ADDENDUM NUMBER 1
TO THE DRAWINGS AND SPECIFICATIONS

PROJECT: Towanda Elementary School 2018 Reroof

A/E PROJECT NO: 23092117

ROOF PLAN ADDENDUM 1

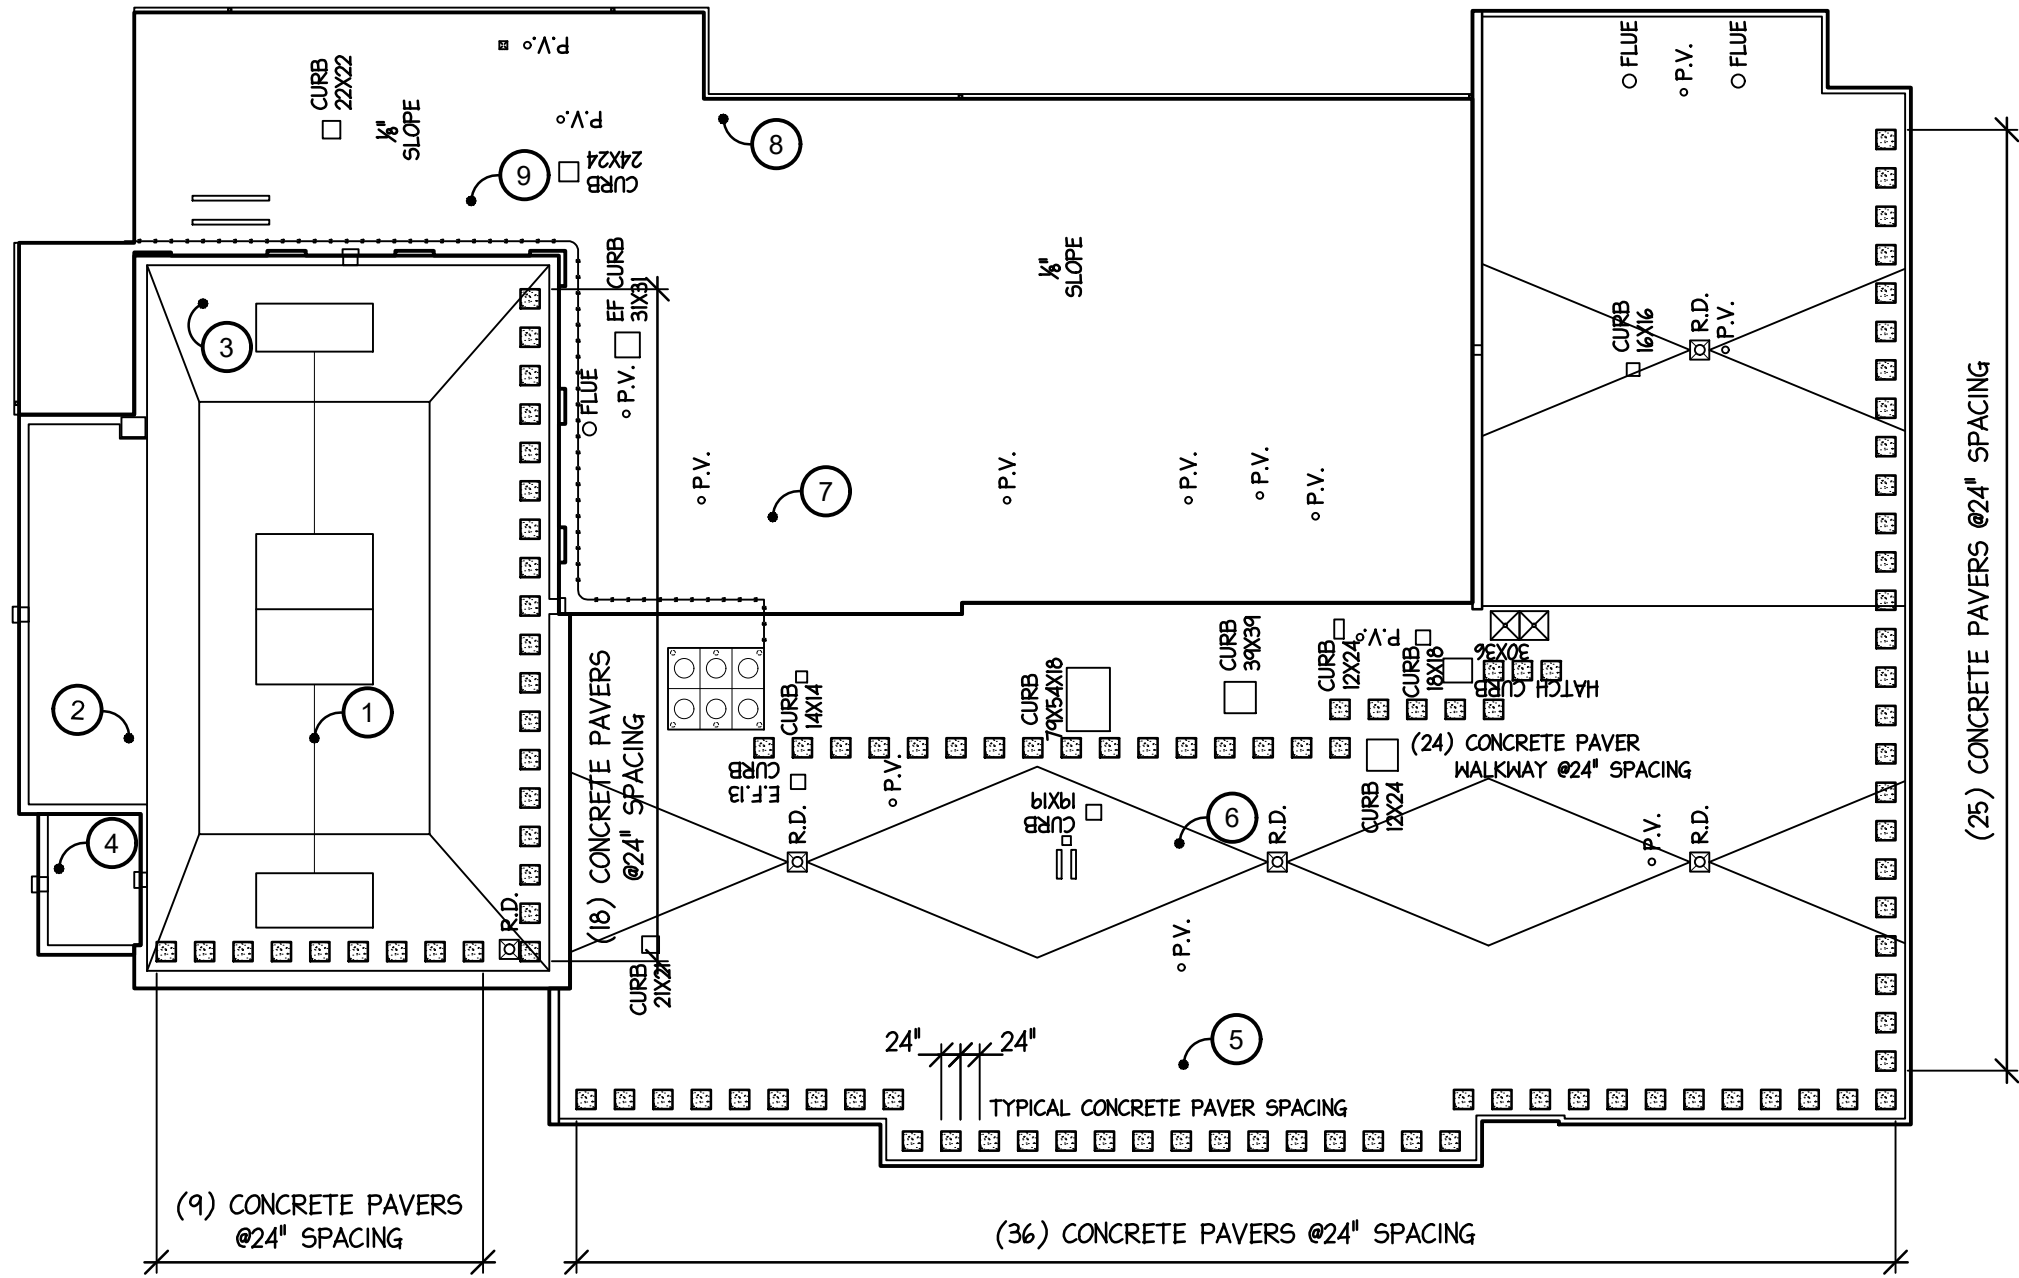
2. TO THE DRAWINGS: Add Sheet R-3 (attached). This drawing shows the paver layout. This drawing shows the roof cuts that were documented.
3. TO THE DRAWINGS: Sheet R-1: The flue toward the southeast edge of 1990 addition is shown to be replaced (detail 5/R-1). This flue is to be removed above and below roof. Below the roof there is about 24” of the flue hanging in place not connected. Remove the flue and roof over.
